P 531100

**ON-SITE SEWAGE DISPOSAL SYSTEM
HOWARD COUNTY HEALTH DEPARTMENT
BUREAU OF ENVIRONMENTAL HEALTH**

SUBDIVISION: Brighton Mill LOT NUMBER: 18

ADDRESS: 13569 Broccolino Way PROPERTY OWNER: NVR, INC.
Highland Development

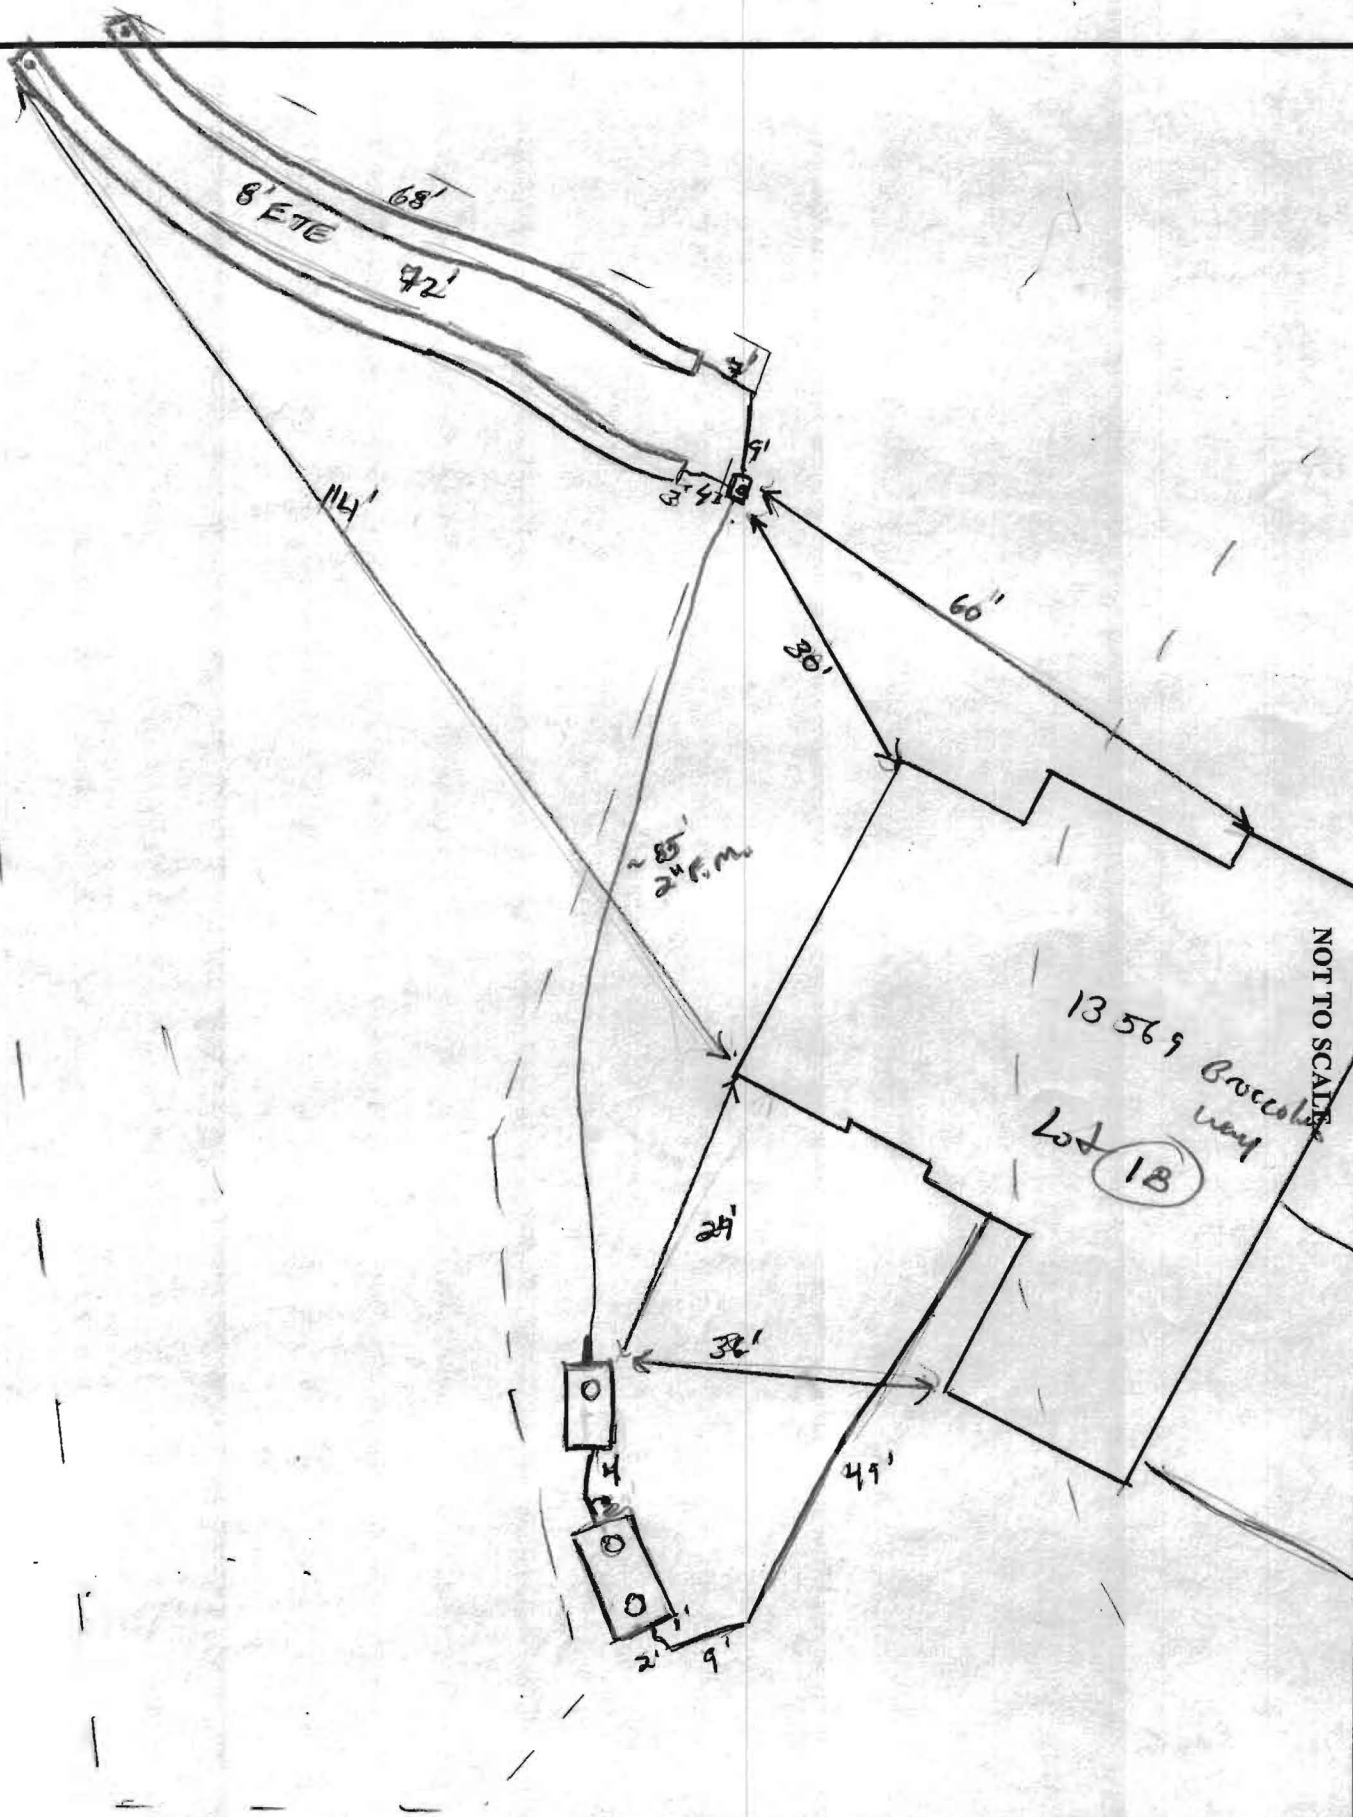
8/10/09 Contractor to set tanks per approved RP plan. Install 2x70' trenches @ inlet 4" bottom 6". Stone is @ breaking point. Slightly dirty. (KW)

8/11/09 D box set. Trenches started ~ 7-10' or so into SDA. Should be OK. Top far corner of SDA falls off, OK to continue. (KW)
 8/12/09 Septic tank and pump tank set along side SDA closer to wards house out of well box radius. OK. 2" F.M. on the D box. 4" SWE installed. OK to cover all work. Need P/A test for final approval (KW) 9/23/09 P/A test OK (KW)

WALL CHECK
BRIGHTON MILL
LOTS 1 THRU 22
PLAT No. 19463
LOT No. 18

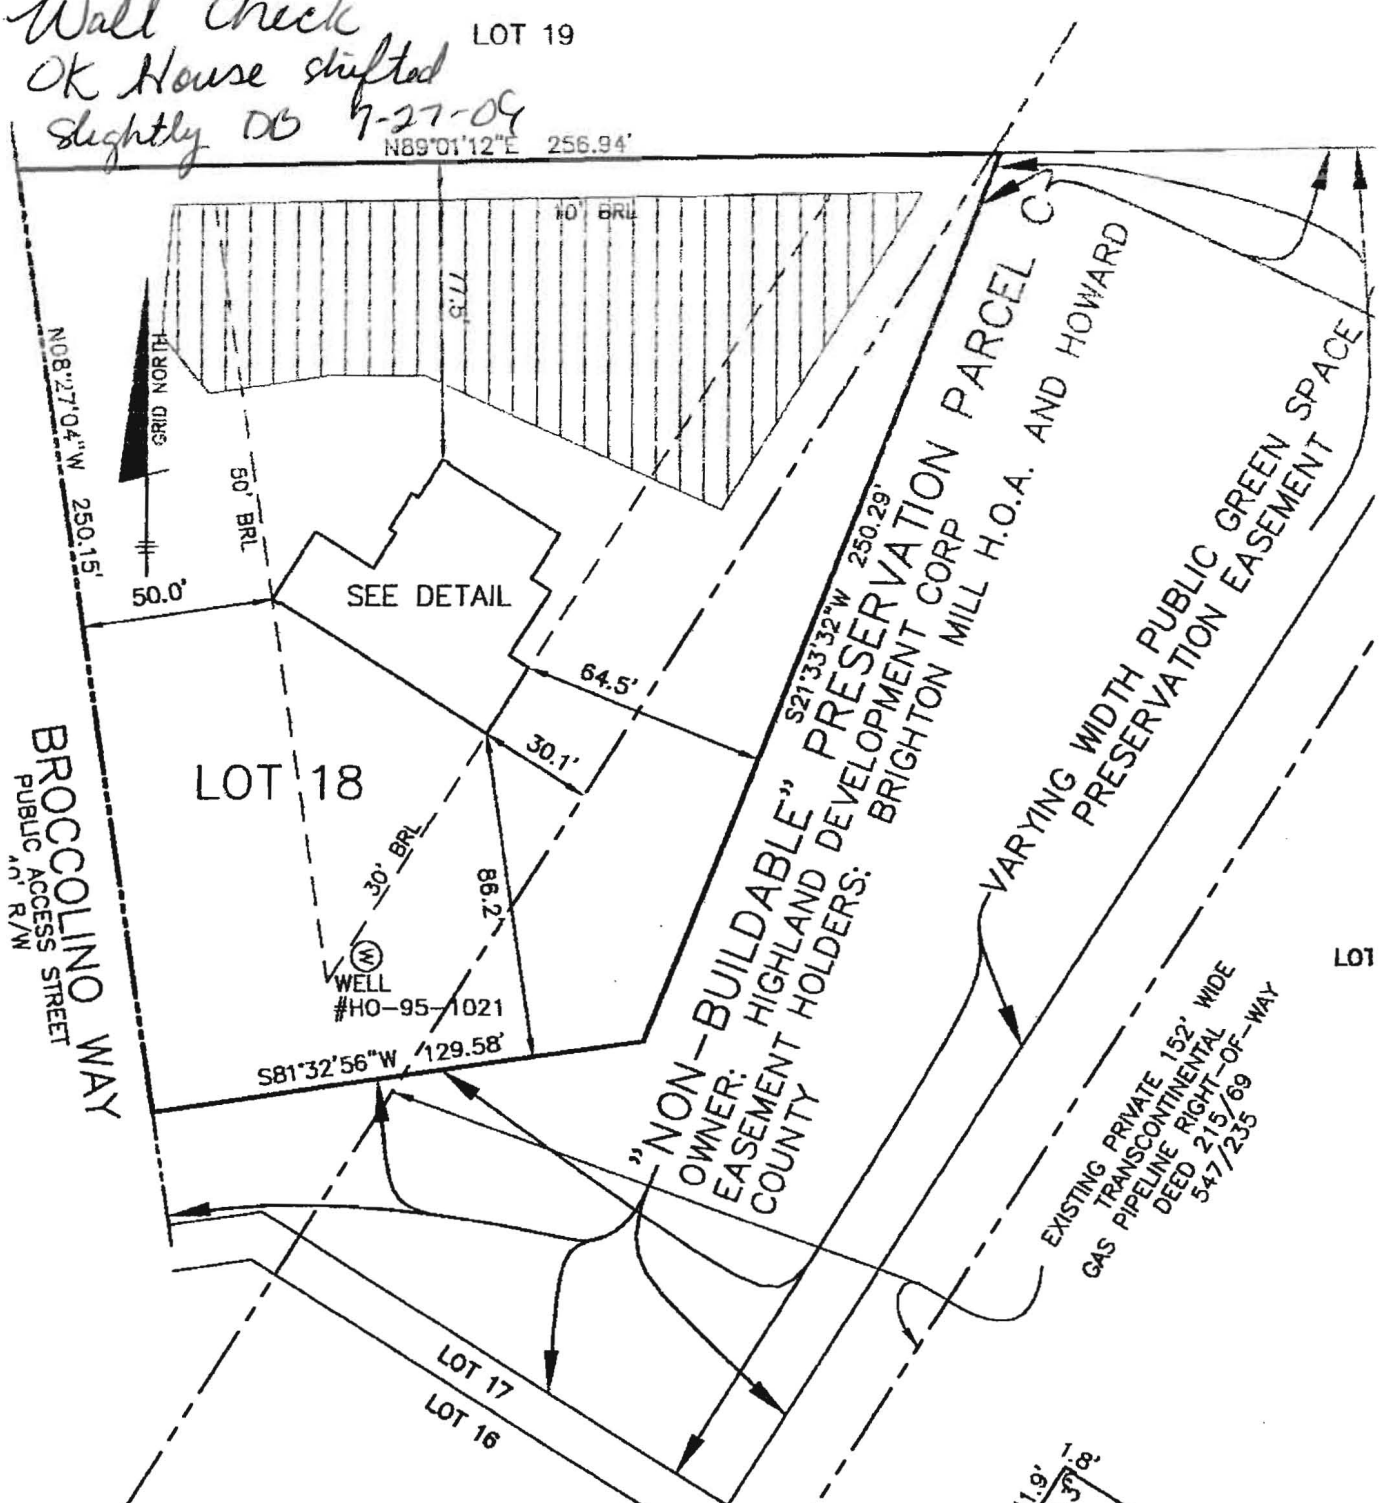
Wall Check
OK House shifted
slightly DB 7-27-09
